Further Objection to Planning Application W/24/0706

Site: Land off Oakdene Crescent, Hatton Station

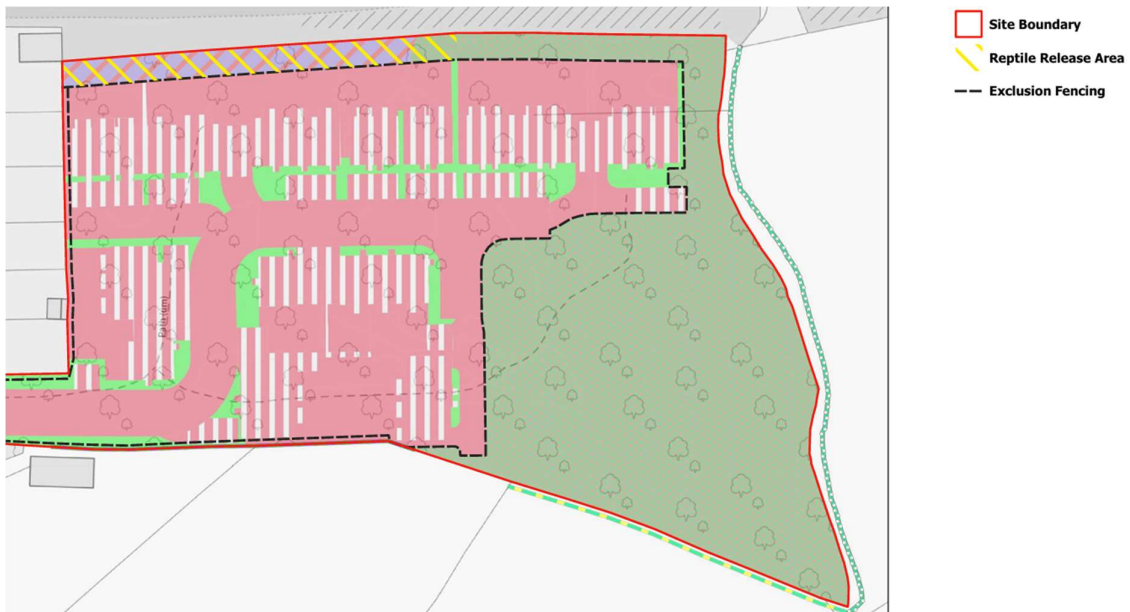
“The receptor area will consist of retained habitat with sufficient carrying capacity to accommodate the translocated reptiles. This may need to include offsite land to which they can naturally disperse.”

The exclusion fence gives reptiles access to the area of retained woodland. The impression is given that this area would be undisturbed with the work area being within the exclusion fence.

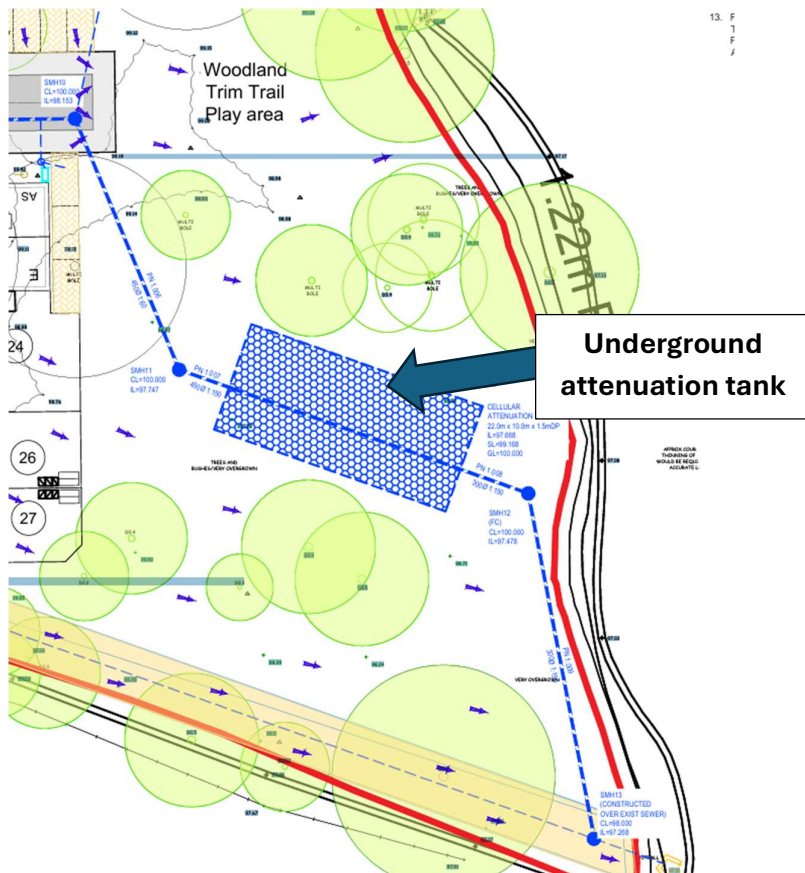
This, however, is simply not the case as another plan of the site makes clear.

Extensive groundworks are needed within the retained habitat including the installation of a 22m x 10m underground attenuation tank plus all the related drainage works.

This is not the only work required. The same plan shows part of the retained habitat contains a trim trail and children's playground. Reference should be made to report by Arena Geo, November, 2023, indicating that arsenic and asbestos were found on the site.

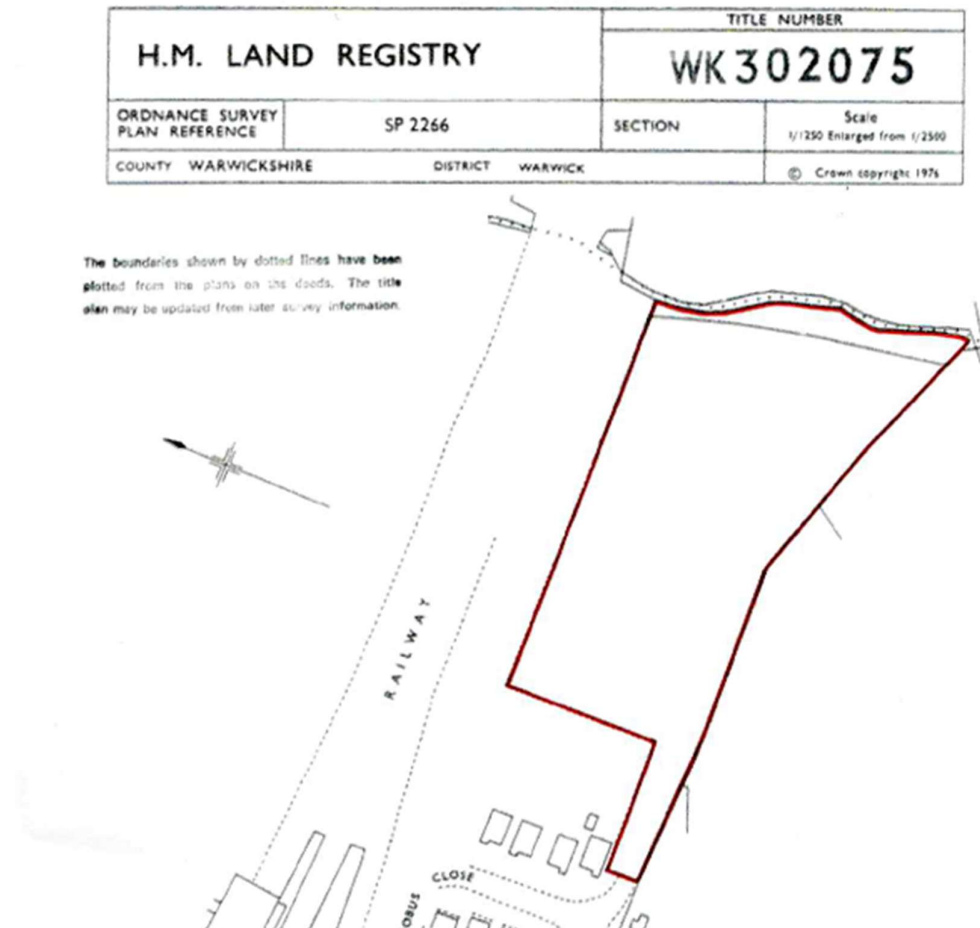
7.1.3 Also at point 2, Ms. Lynes continues:

“Where it is proposed to discharge directly into the ordinary watercourse, suitable proof of land ownership showing riparian ownership must be provided, in addition to evidence that the watercourse is in sufficient condition to receive flows.”

In the response from Pegasus, these important points are simply ignored.

Reference was therefore made to the Land Registry. This site plan seems to indicate that the site boundary is on the western side of the stream and **DOES NOT** cover the stream itself. The stream would appear to be on Arkwright land. This would make sense as it crosses Arkwright land before it reaches the site at the northeastern corner and, where the stream departs from the site at the southeastern corner, it flows wholly across Arkwright land until it passes under Station Road. In addition, there are the remnants of a post and wire fence along

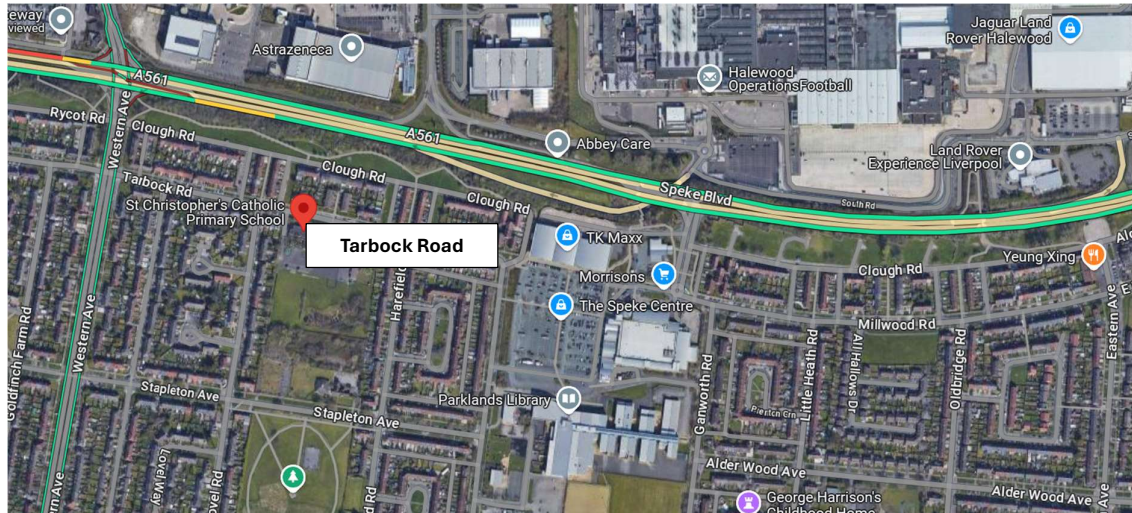
- A statement that a range of facilities and services are reachable from the site by sustainable means. (Untrue)
- Footways provide pedestrian access to facilities including retail opportunities, primary schools and pubs. (Untrue)
- Bus frequencies are misquoted.
- Train frequencies stated are incorrect.
- Likely car ownership has been extrapolated from a tiny sample.
- Trip generation figures are extrapolated from data relating to edge of town locations which have good access to public transport and services within walking distance. They are not remotely comparable to our tiny rural settlement. Are we really to believe that only 14 vehicles will enter or exit the site during peak hours and 12 during evening peak hours?

Note 1: Here is an example of how absurd their trip generation statistics are. I recently visited one of the locations supposedly comparable to Hatton Station – Tarbock Road in Speke, a suburb of Liverpool. This location could not be more urban. Tarbock Road runs parallel to the main dual carriageway leading directly to Liverpool City Centre. There are bus stops and a retail park containing a large supermarket within walking distance. There is easy access to a range of employers, schools and Hunts Cross station.

The IndieGo on-demand bus service (in orange) showing how limited the service is.

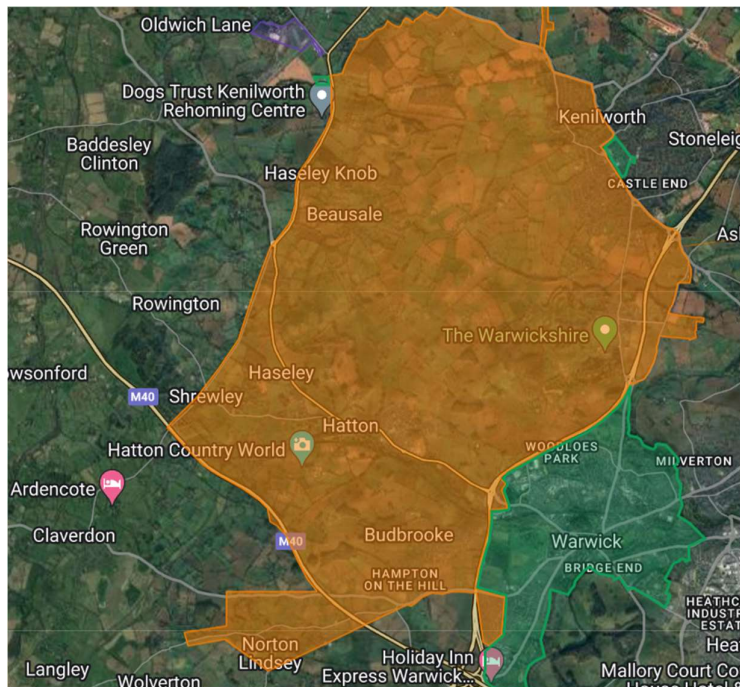
The orange portion of the map below is the area covered by the service. There are several important places which it is impossible to reach:

- The nearest doctor's surgery in Claverdon;
- The primary school in Claverdon;
- The leisure centre at St. Nicholas Park in Warwick;
- Solihull town centre;
- Leamington town centre.

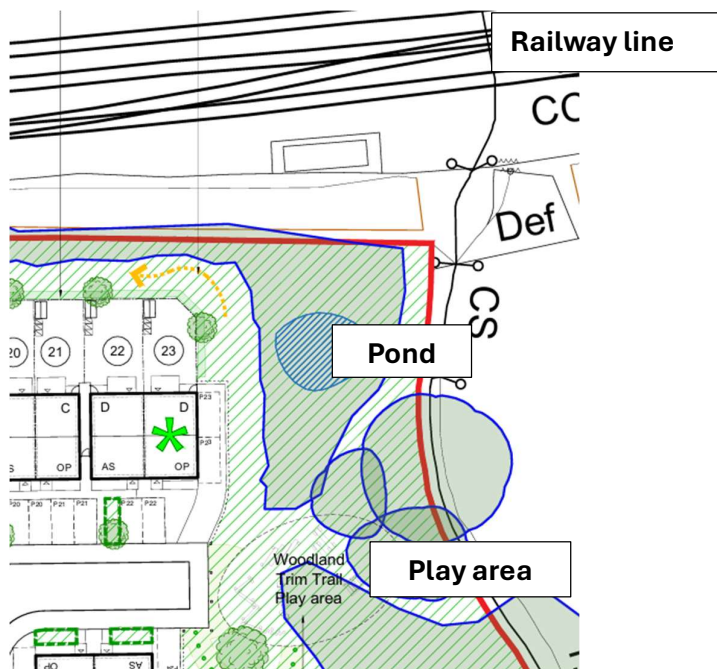
This photograph is taken on the northern edge of the site at the bottom of the railway embankment and shows that the boundary is marked by a post and wire fence which is in generally poor condition.
